PLANNING UNIT REPORT  
DEPARTMENT OF PLANNING AND DEVELOPMENT  
February 6, 2006

**ZONING MAP AMENDMENT, I.D. AND PRELIMINARY/FINAL PLAT APPLICATION:**

1. Requested Action: Approval of a zoning map amendment from Temporary A-Agriculture to R2S and a preliminary/final plat known as "Emerick Oaks" located at 9624 Old Sauk Road.
2. Applicable Regulations: Section 28.12(10) provides the process for zoning map amendments. Section 28.08(13) provides the framework and regulations for the R2S Single-Family Residence District. All subdivisions within the City of Madison must comply with Section 16.23, Land Subdivision Regulations, Madison General Ordinances.
3. Report Drafted By: Peter Olson, Planner II.

SUBJECT: **9624 Old Sauk Road – Rezoning / Preliminary & Final Plat– Temp A to R2S / Emerick Oaks - Town of Middleton Sec. 16**

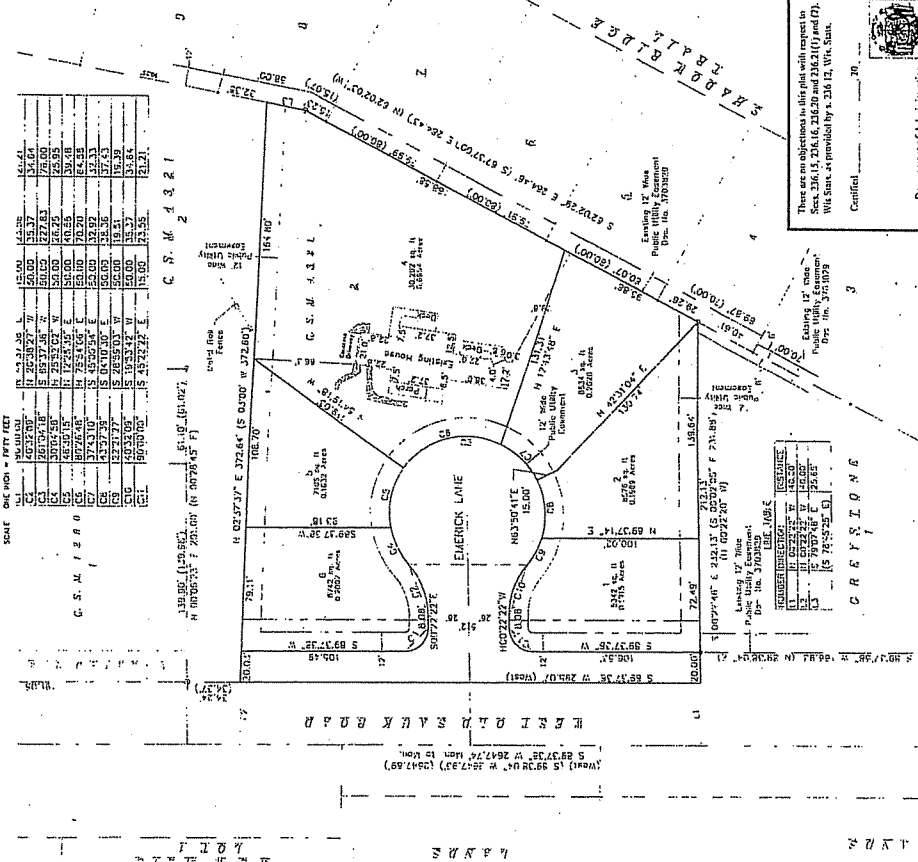
1. Change Lane to Court. Street is Old Sauk Road not West Old Sauk Road due to annexation.
2. Each lot will require a separate sanitary sewer lateral.
3. Prior to approval, owner shall provide evidence that the proposed plat is within the Central Urban Service Area and eligible to receive sanitary sewer service.

4. The Developer shall extend public sanitary sewer at his/her cost, from Cricket Lane, to serve proposed development.
5. 9624 Old Sauk Road address will be changed to an Emerick Court address. Change plat title to City of Madison and on surveyor's certificate.

7. The Developer shall note that a considerable amount of excavation will be required on Emerick Court and the proposed grade of the street will be much lower than the existing grade near the existing home. A significant retaining wall shall be required on Lot 4 of the Plat.

- On Lots 2 and 3 show a front building setback line where the lot meets the 40' minimum width requirement. Note: Lot 3 meets the 40' lot width requirement at approximately the 13' sewer easement setback. Show building setbacks of the existing house to remain on Lot 4.
